SUBJECT: ADDENDUM # 1

PROJECT TITLE: New Cooling Tower & Enclosure

PROJECT NO.: BI-2B-272

**COOLING TOWER REPLACEMENT
61 WOODLAND STREET
HARTFORD, CONNECTICUT
PROJECT: BI-2B-272**

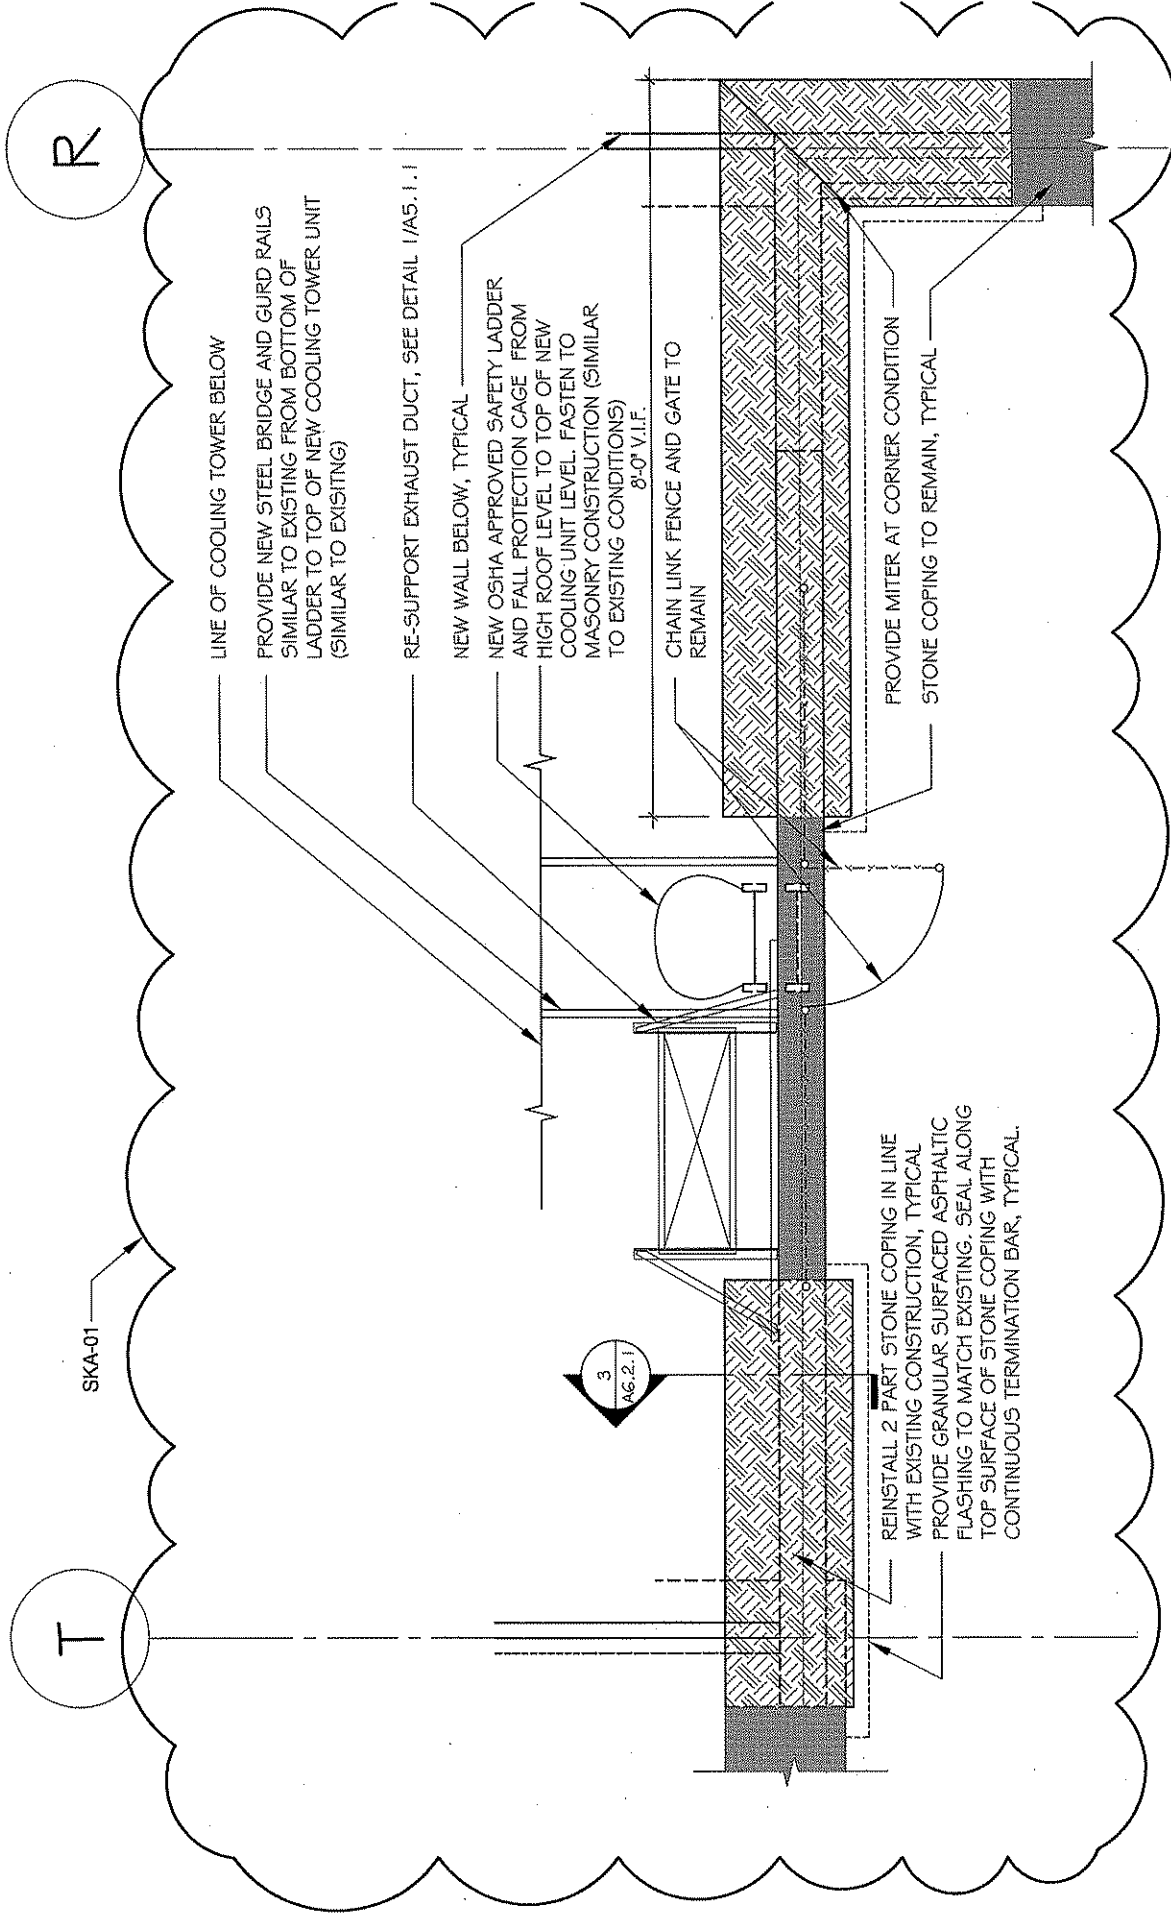
West Elevation 1/A3.1.2 and roof level demo plan 2/A2.1.2 show the chain link fence, railings and ladder being removed. Partial high roof plan 2/A2.4.1 shows the fence and ladder in place and partial stone coping reinstallation. West Elevation 1/A3.2.2 shows salvaged stone coping installed across the entire high roof parapet with no fence or ladder. Partial high roof plan 2/A6.2.1, for Supplemental Bid #1, also shows the existing fence and ladder (with new safety cage) to remain and partial stone coping reinstallation. Please clarify the high roof parapet work for both Base Bid and Supplemental Bid #1.

Substitute detail SKA-001 in lieu of 2/A6.2.1 for clarification of parapet replacement scope.

Supplemental Bid:
